## **STAFF REPORT AND RECOMMENDATION TO THE DESIGN COMMISSION - DENIAL**

CASE FILE: LU 15-259840 DZM  
PC # 15-177695  
1111 SE Sandy Blvd  
REVIEW BY: Design Commission  
WHEN: February 4, 2016, 1:30pm  
WHERE: 1900 SW Fourth Ave., Room 2500A  
Portland, OR 97201

The Burnside Delta project is proposed on a triangular 10,231 SF site at a Central City Gateway location – E Burnside and SE Sandy Blvd. The proposed building is 6 stories above a basement level built into the slope of the site which drops approximately 14’ in approximately 200’ on the E Burnside frontage. Approximately 2,500 SF of retail space is proposed on either end of the E Burnside frontage at SE Sandy Blvd and SE 11<sup>th</sup> Ave. 85 residential units are proposed on levels 1-6 and a community room and deck are proposed on level 6. Both residential lobby and garage access (18 vehicle parking spaces and 56 bike parking spaces) are proposed on SE 11<sup>th</sup> Ave at mid-block. The proposed primary exterior cladding is 3/16” tread-plate steel (primary) accented with 22 gauge flush seam metal panel. 25 balconies (30% of total units) are proposed on levels 3-7.

EXTERIOR ELEVATION - NORTH

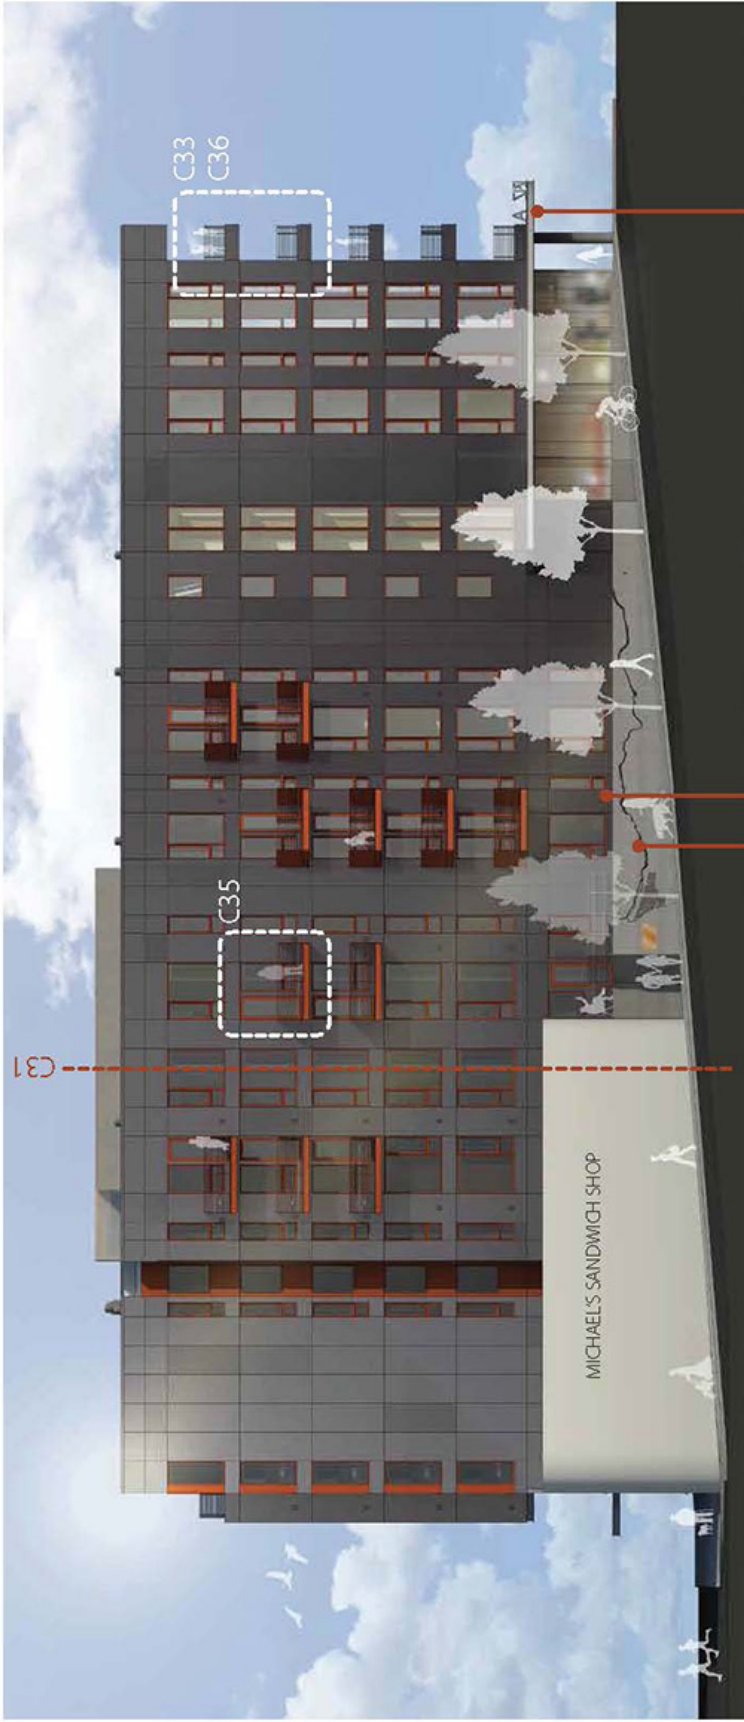
The Applicant’s response to this direction was limited to the extension of canopies and balconies over the E Burnside St sidewalk – the 11<sup>th</sup> Ave retail/residential lobby canopy by 8’, the Sandy Blvd/E Burnside retail canopy by 6’ and the recessed balconies by 4’ on levels 3-6. The Applicant cites grade as the primary constraint to any greater degree of arcade expression involving floor area projections. Staff recognizes the significance of the grade condition as an impediment to spill-out potential, yet finds that the connectivity of all-weather protection offered by the arcade and the significance of the tradition (especially at this gateway location) are important factors deserving fuller resolution.

Staff’s recommendation is that in order to meet this guideline some amount of building mass projection should be provided – at least 6 to 8 feet, whether arcaded or cantilevered – along one third of the E Burnside frontage. Staff finds that the proposed cantilevered canopies and balconies neither sufficiently narrow the perceived width of E Burnside nor protect the pedestrian from curb-tight bus traffic as encouraged by the guideline.

***Therefore, this guideline is not met.***

However, because the proposed application of tread plate steel is a significant departure from convention, it is essential that renderings be provided that accurately convey the appearance of the tread plate material as detailed. Because the renderings submitted by the Applicant do not clearly depict the material, a wall mock-up shall be presented at the hearing. Until the mock-up is reviewed by Staff and the Commission, it is not possible to determine if the proposed tread plate steel will result in a coherent composition.

***Therefore, this guideline is not yet met.***

FLOOR PLAN - BASEMENT  
1/16" = 1'-0"

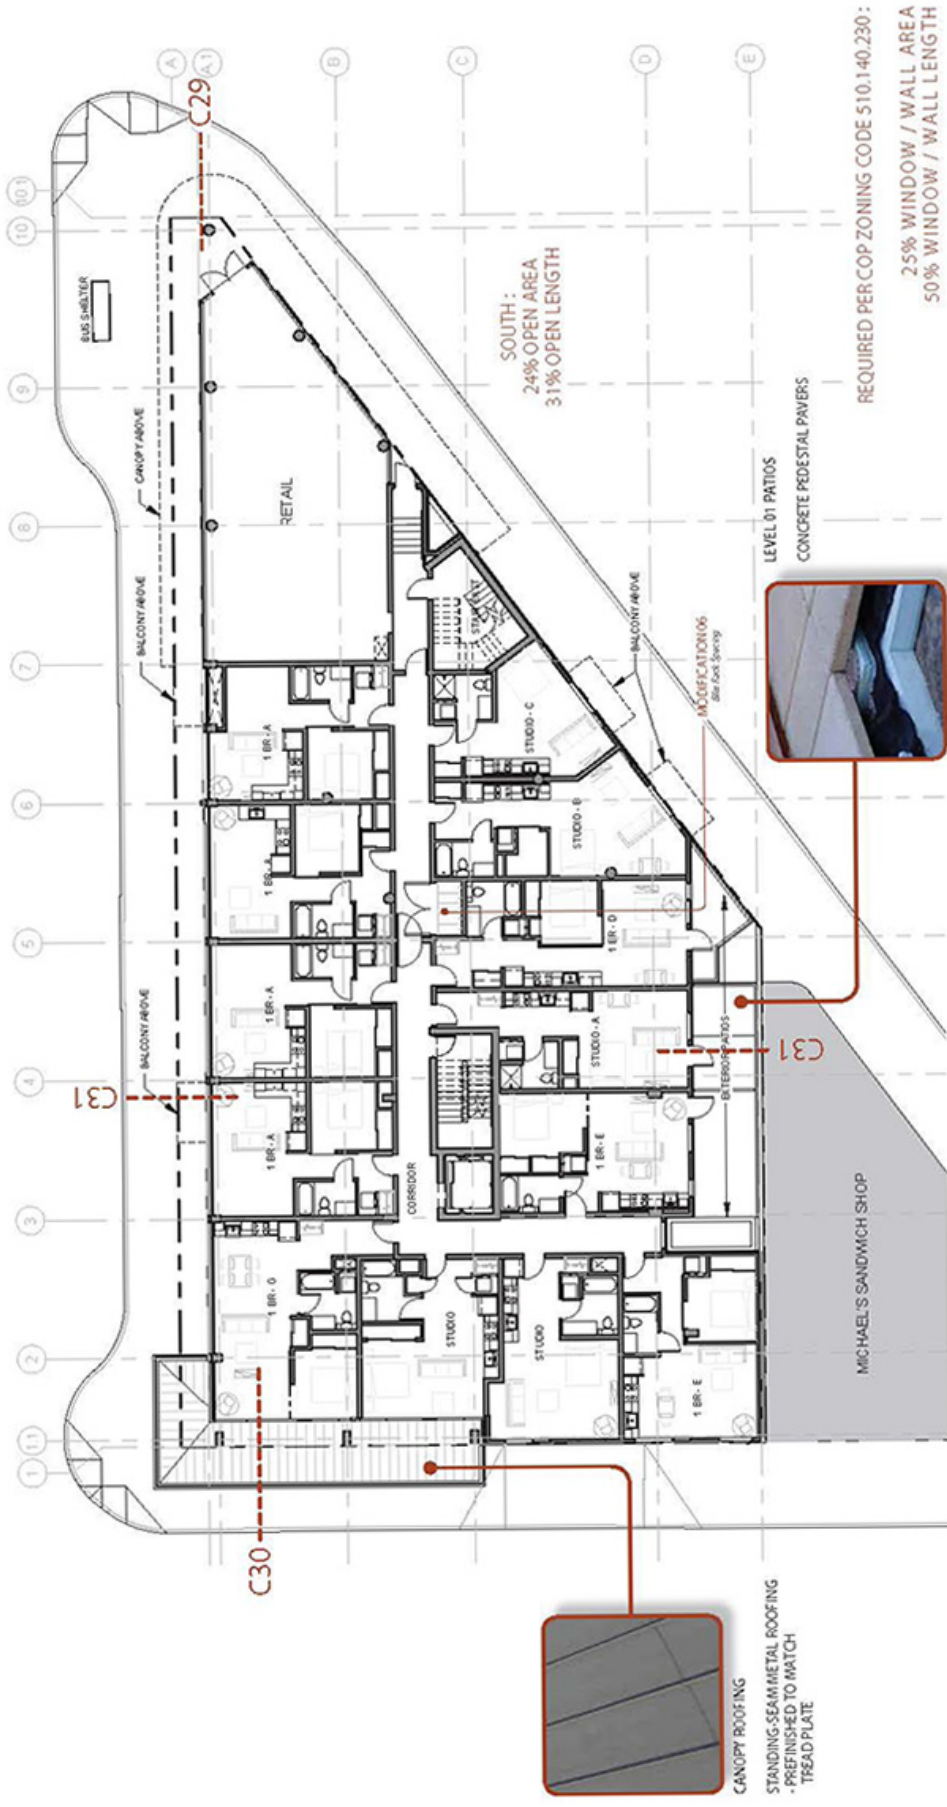
**Findings:** As evidenced in the findings for guideline C1-1 above, the Standard B stall (9’Wx18’Lx10’H) is proposed to partially block an internal drive aisle which requires a Modification to PZC 33.266.130 F.1.a, Parking Area Layouts requiring that parking areas be designed so that a vehicle may enter or exit without having to move another vehicle (Please refer to Modification #1 in Section 2 of this Staff Report). PBOT has indicated that prior to supporting this Modification, a Queuing Analysis shall be submitted. At the time of the publication of this Staff Report, no such analysis had been submitted. As such, Staff cannot determine that the parking layout as proposed will better meet Guideline C1-1.

***Therefore, this modification request does not yet meet the approval criteria.***

**Modification #1: 33.266.130 F.1.a, Parking Area Layouts.** Parking areas shall be designed so that a vehicle may enter or exit without having to move another vehicle. PBOT has indicated that prior to supporting this Modification, a Queuing Analysis shall be submitted. At the time of the publication of this Staff Report, no such analysis had been submitted. As such, Staff cannot determine that the parking layout as proposed will better meet Guideline C1-1. *Therefore, this modification request does not meet the approval criteria.*
